PCN – Process Change Notification

Change:	MA600.A.ABC.007
Date:	2017/07/13
Author	Haley Tsai

Model#	Part Number	Changes
Spartan GPS/GLONASS/GALIL EO-SMA(M)3M RG174/Cellular- SMA(M)3M CFD- 200/WiFi-RP-SMA(M) 3M CFD-200	MA600.A.ABC.007	<ol style="list-style-type: none"> Part number should be "MA600.A.ABC.007" instead of "MA600.A.ABC.0007". Amend label material to PEPA. Change 2.4/5 GHz label to 2.4/5.8 GHz label. Amend washer and nut model type to Steel AISI 1215. Amend housing dimension from 147.5mm to 147.31mm. Amend \varnothing145.6 tolerance from +/-2.0mm to +/-0.5mm. Add housing top to adhesive dimension 36+/-1mm. Add adhesive to M30 thread dimension 30+/-2.5mm. Amend M30 nut tolerance from +/-0.3mm to 0.5mm. Add barcode label. Add dimension from barcode label to GPS-Glonass label. Remove heat shrink tube tolerance. Amend cable length tolerance from +/-30mm to +/-50mm.

Illustration of Change

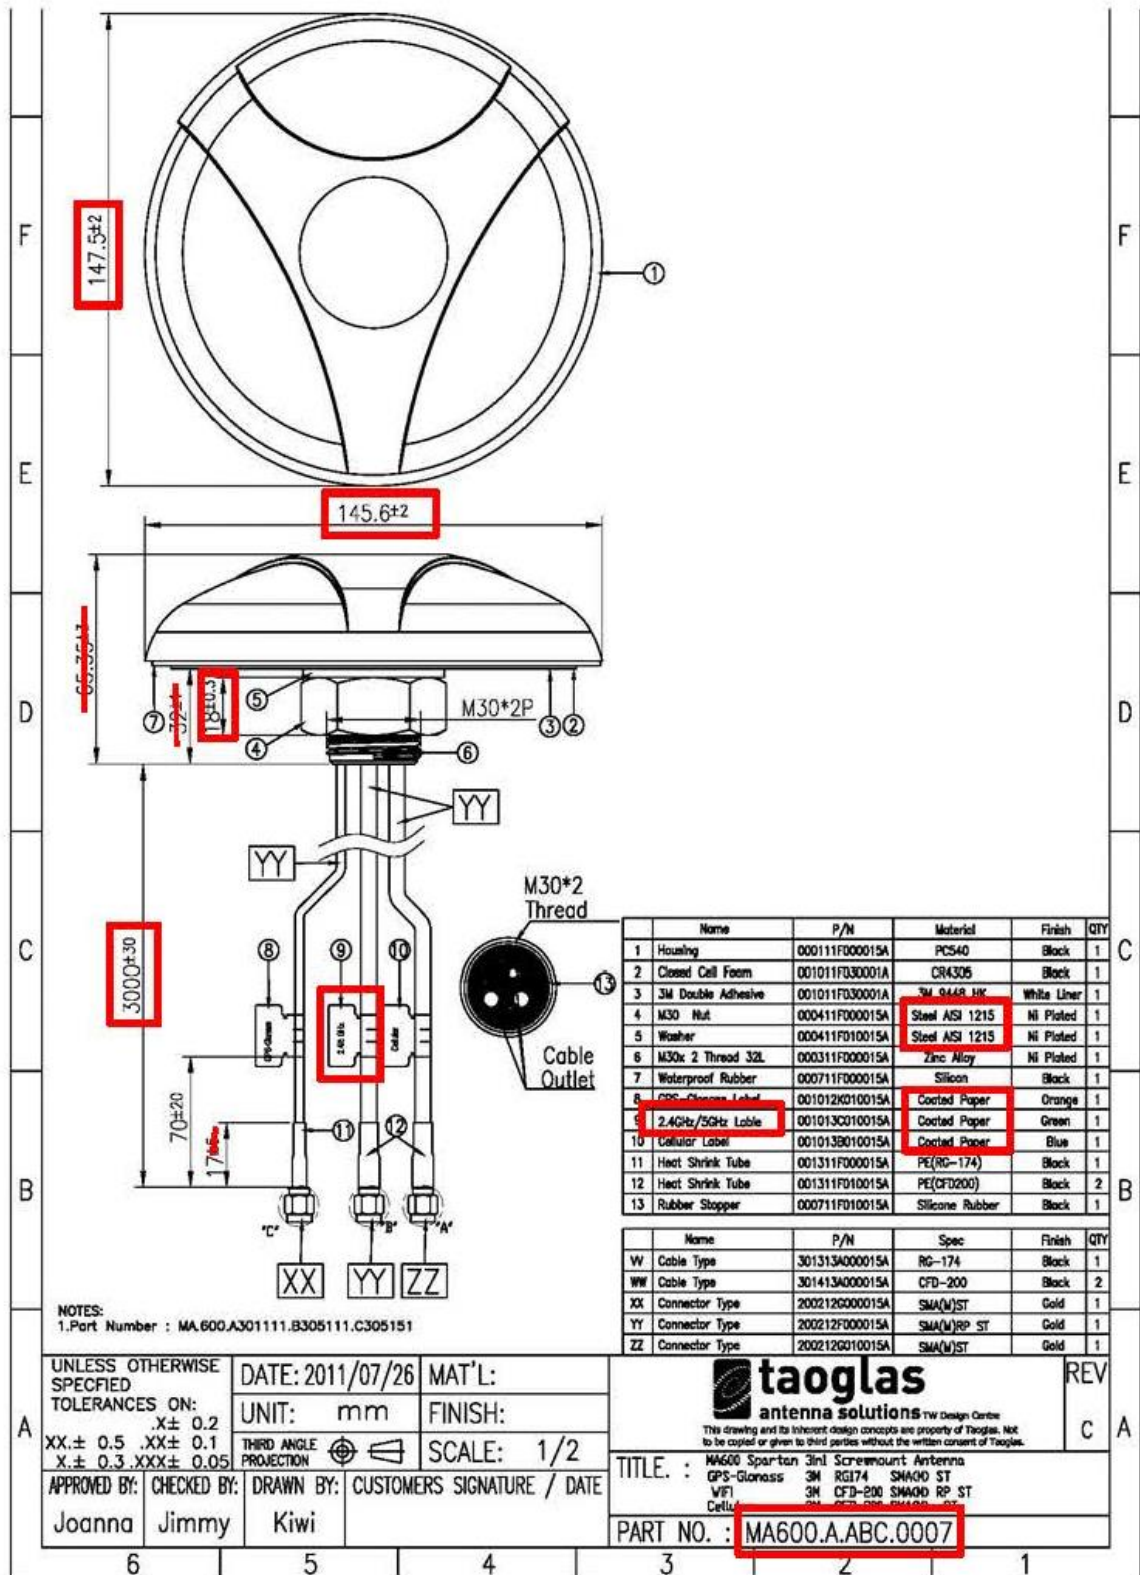
- Part number should be "MA600.A.ABC.007" instead of "MA600.A.ABC.0007".
- Amend label material to PEPA.
- Change 2.4/5 GHz label to 2.4/5.8 GHz label.
- Amend washer and nut model type to Steel AISI 1215.
- Amend housing dimension from 147.5mm to 147.31mm.
- Amend \varnothing 145.6 tolerance from +/-2.0mm to +/-0.5mm.
- Add housing top to adhesive dimension 36+/-1mm.
- Add adhesive to M30 thread dimension 30+/-2.5mm.
- Amend M30 nut tolerance from +/-0.3mm to 0.5mm.
- Add barcode label.
- Add dimension from barcode label to GPS-Glonass label.
- Remove heat shrink tube tolerance.
- Amend cable length tolerance from +/-30mm to +/-50mm.
